**The W Nursing School
Neshoba General
Philadelphia, MS**

Addendum No. 5

June 17, 2026

This addendum forms a part of the contract documents and modifies the original plans and specifications dated June 4, 2026.

5 34" SINK BASE CAB
1 1/2" = 1'-0"

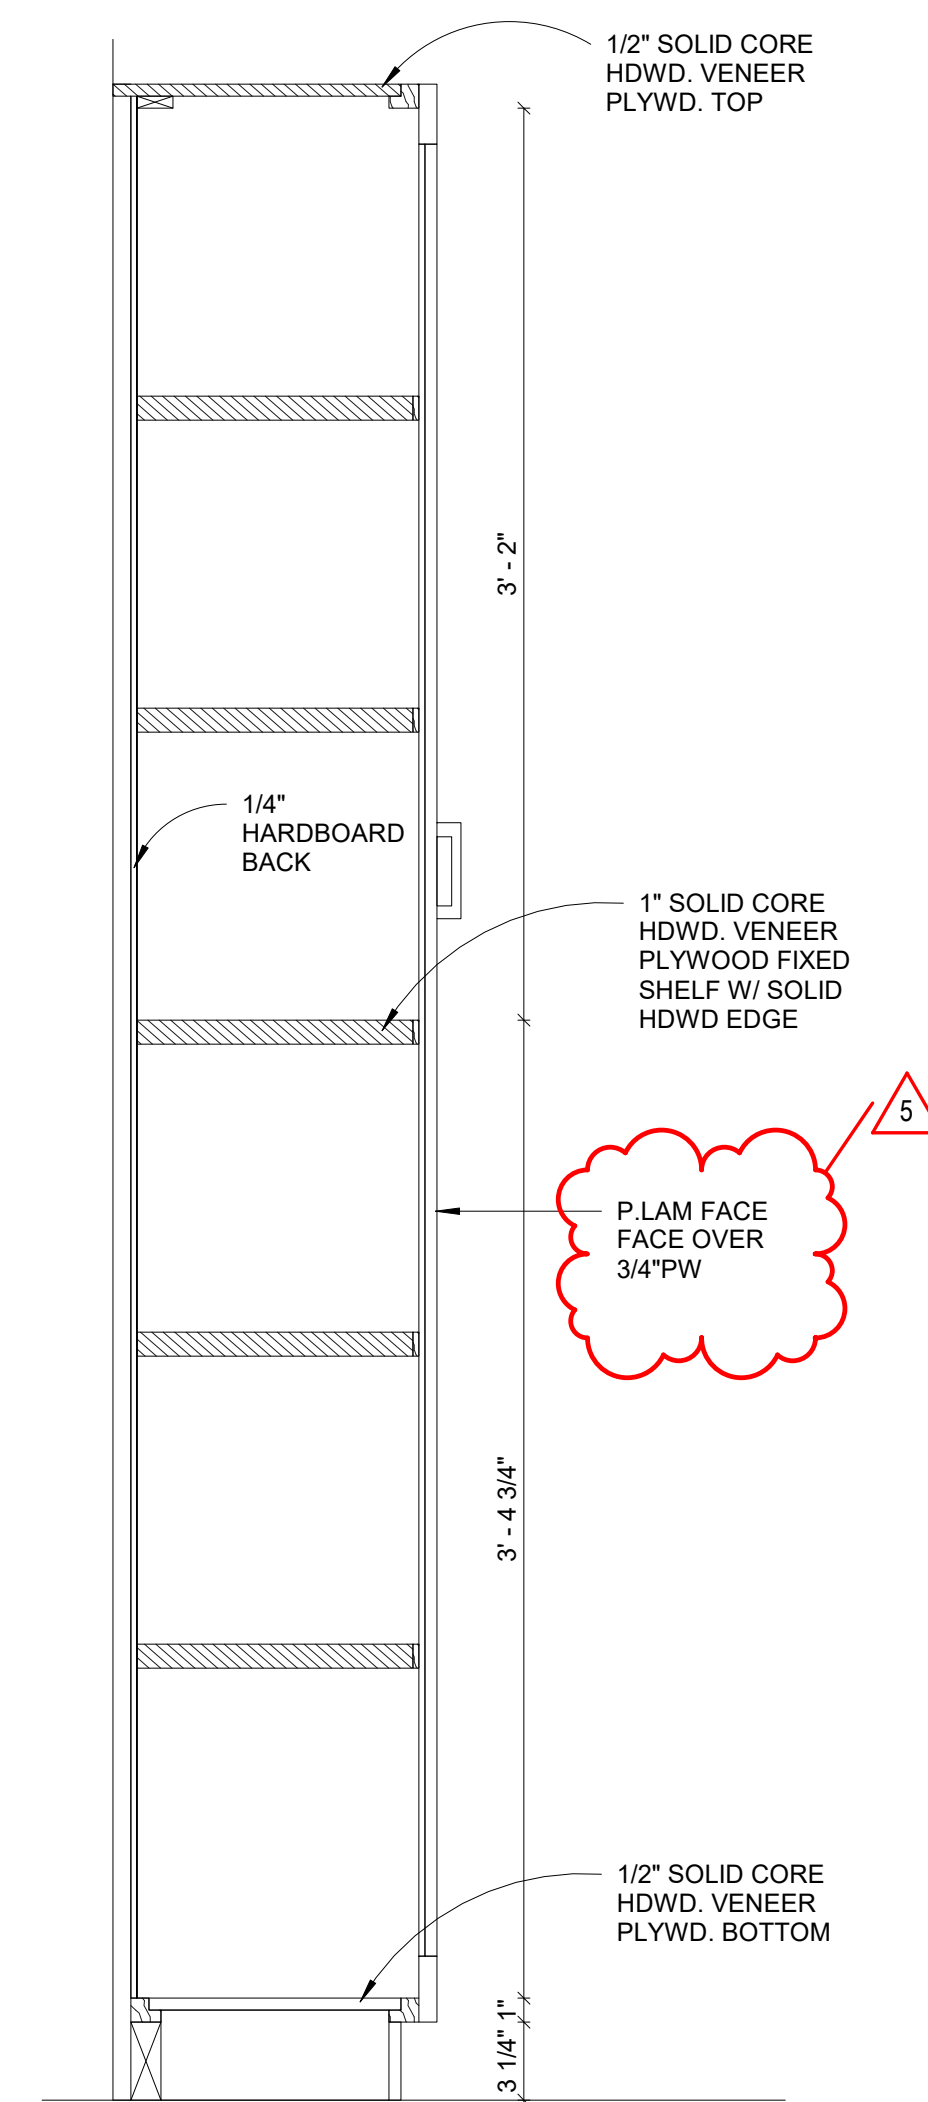
Note: $\frac{3}{4}$ " plywood with P. Lam finish arrow should be to door.

6 84" SHELVING UNIT 12" DEEP
1 1/2" = 1'-0"

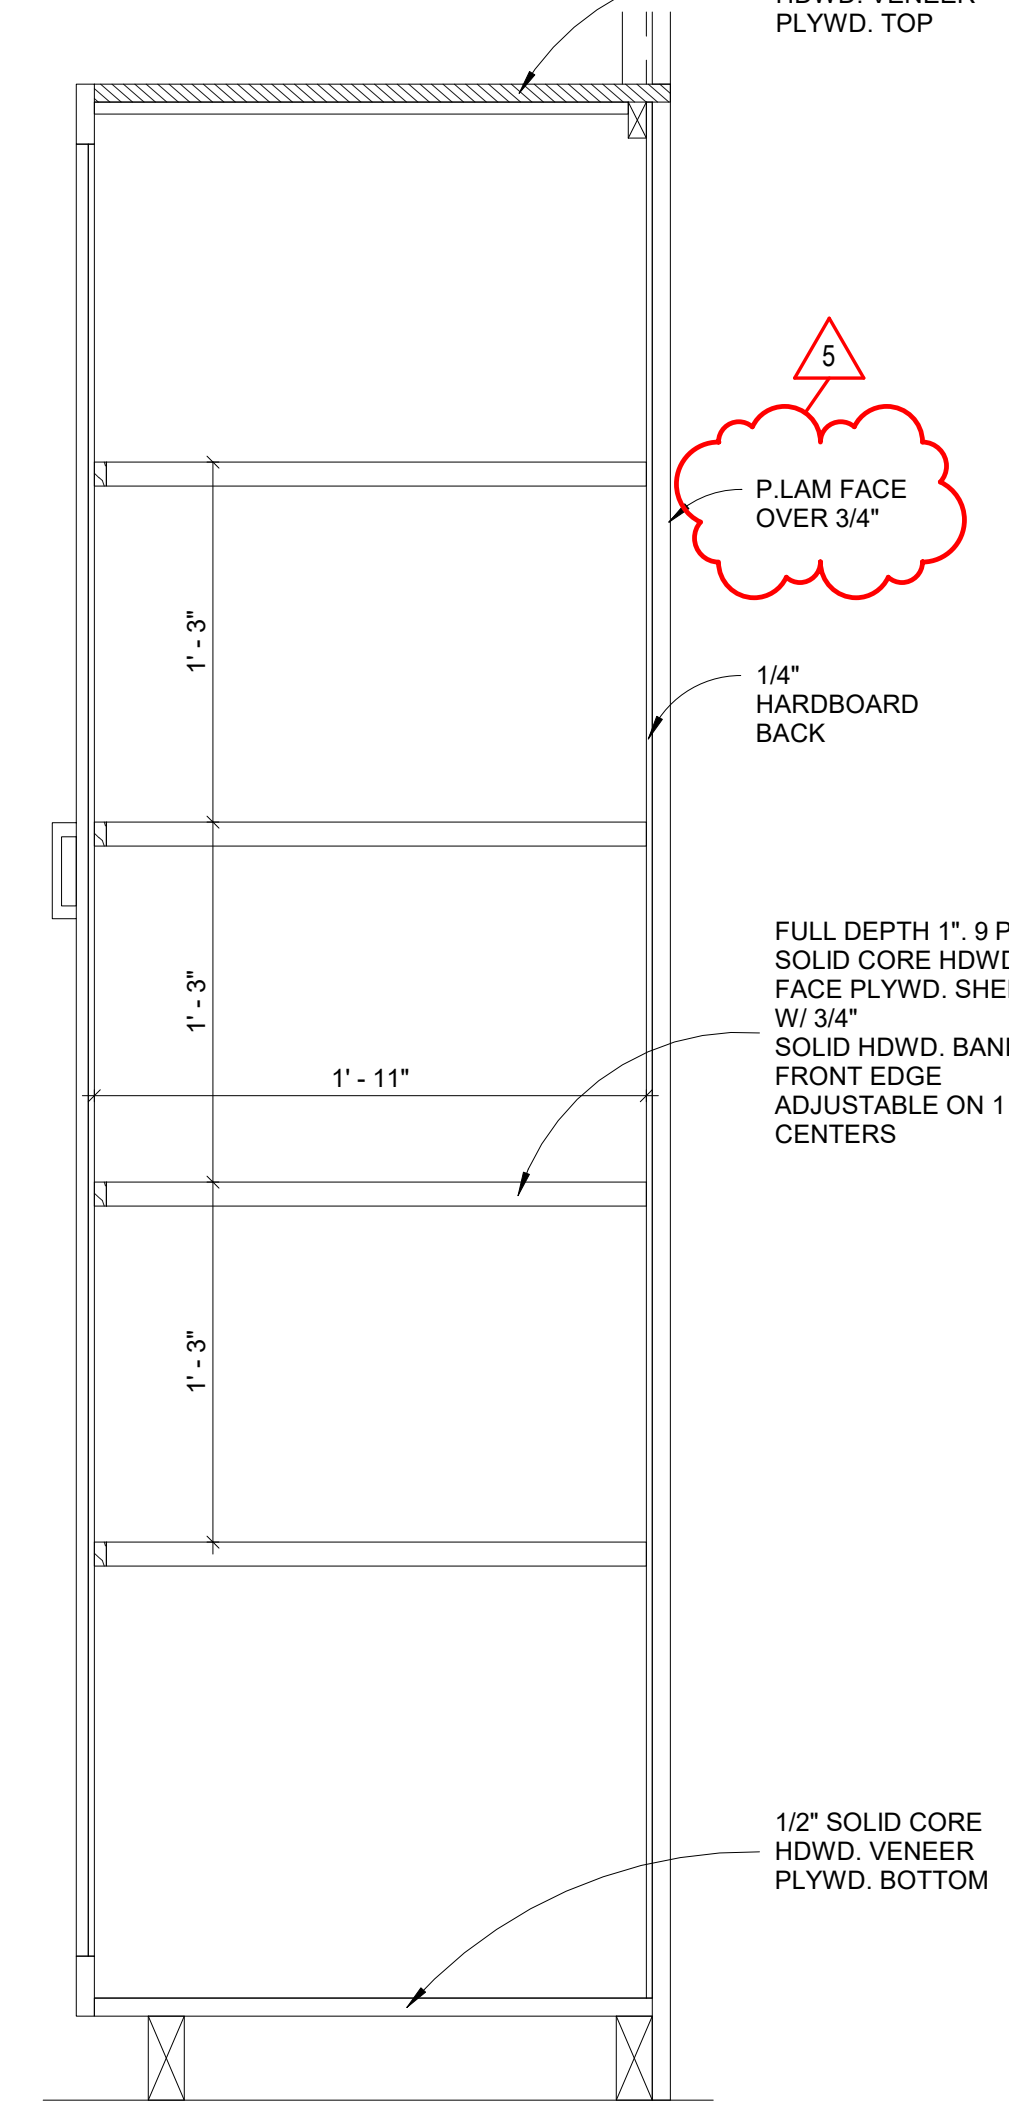
Note: P. Lam face over $\frac{3}{4}$ " plywood to door on cabinet.

10 30" SINK (EXAM RMS) BASE CAB
1 1/2" = 1'-0"

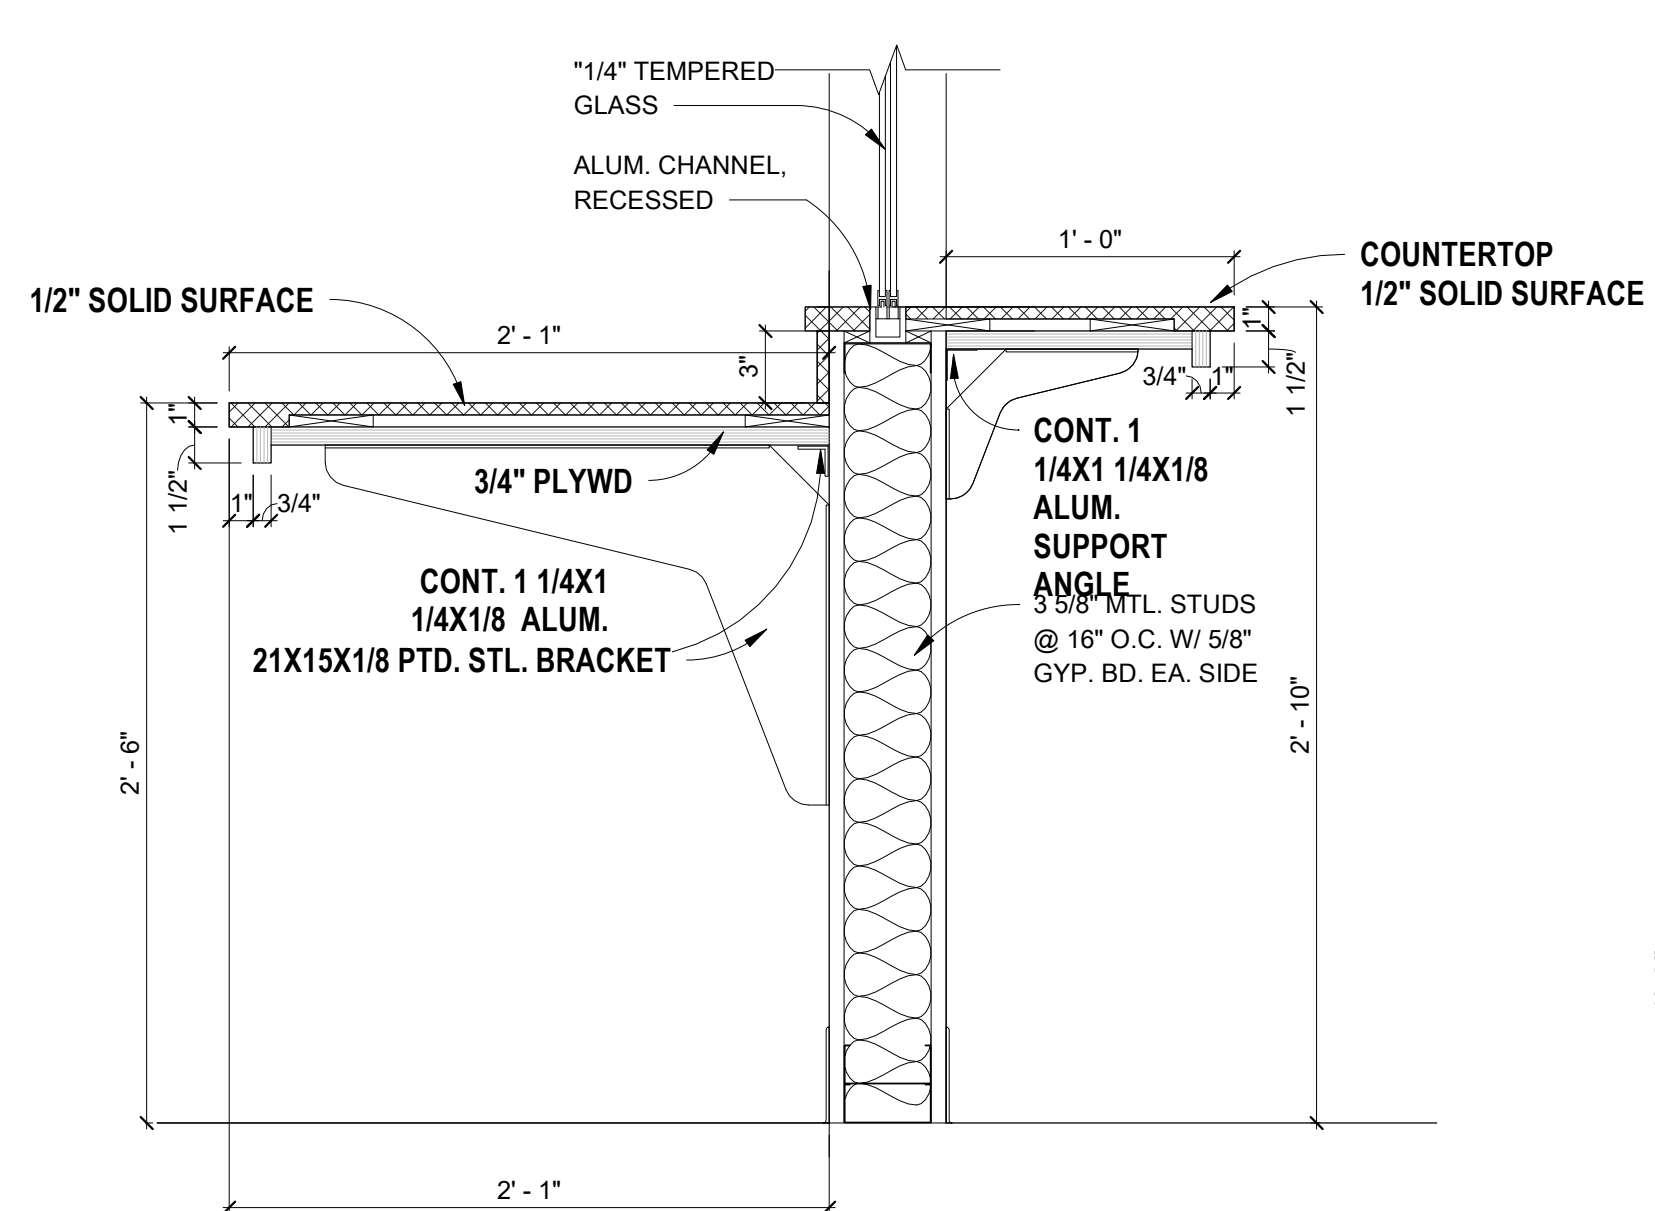
Note: P. Lam face over $\frac{3}{4}$ " plywood to door on cabinet

13 34" H ADA COUNTER W/ KNEESPACE
1 1/2" = 1'-0"

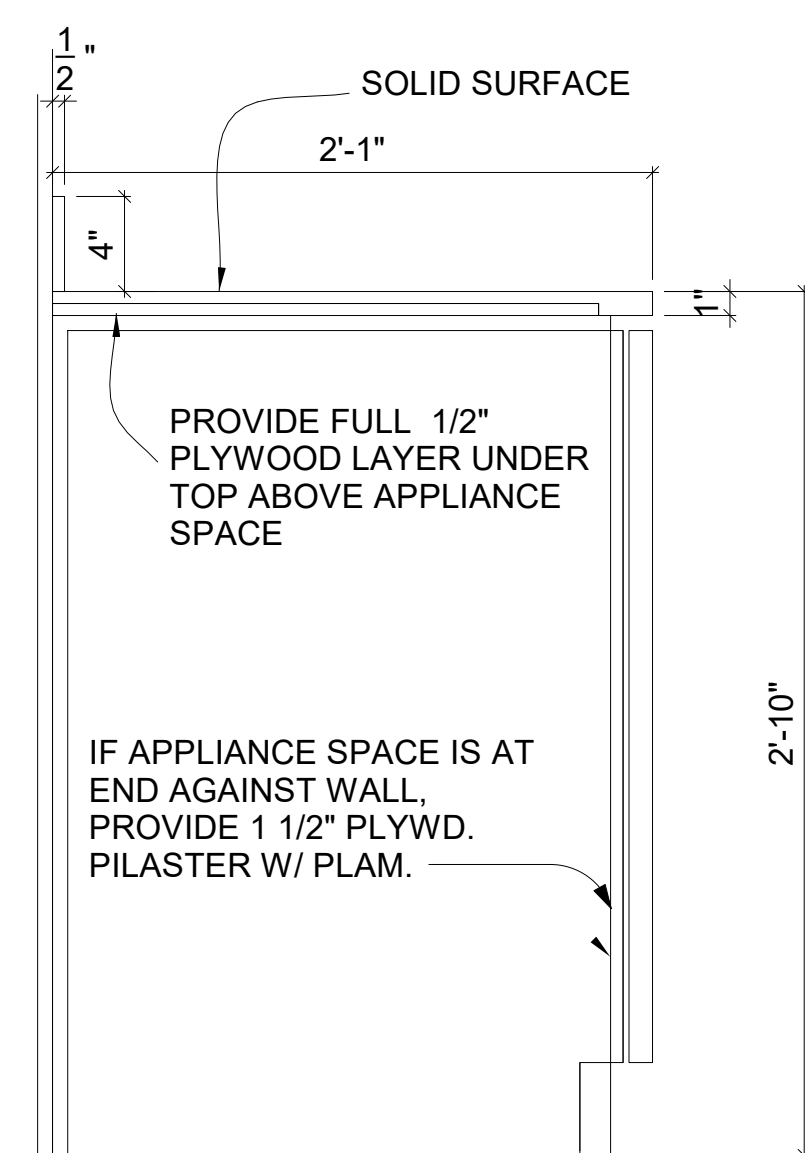
Note: $\frac{3}{4}$ " plywood with P. Lam at work surface.
